Product Change Notification

1. ECN #: 301413

- FTSH - .050" X .050 TERMINAL STRIP

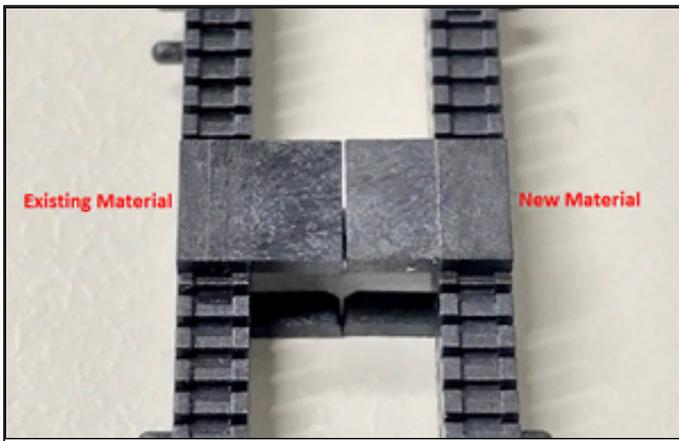
Updated design to the cut area of the body and material change from Vectra E130i to Vectra FIT30; both are high temp LCP. This is being released as a rolling change, which will allow for a possibility of mixed shipments during a limited time frame. The new design will fully replace the existing design once all existing stock material has been depleted.

New cut groove design and material change to lessen the creation of flash during the cut process. Updated design is required for new manufacturing technology being implemented by Samtec. The cut groove design change will not be noticed at the finished good level as it is removed during the cut process. The material change will also have no affect at the customer level as it is also a high-temp LCP with similar processing and temperature ratings as the current material being used.
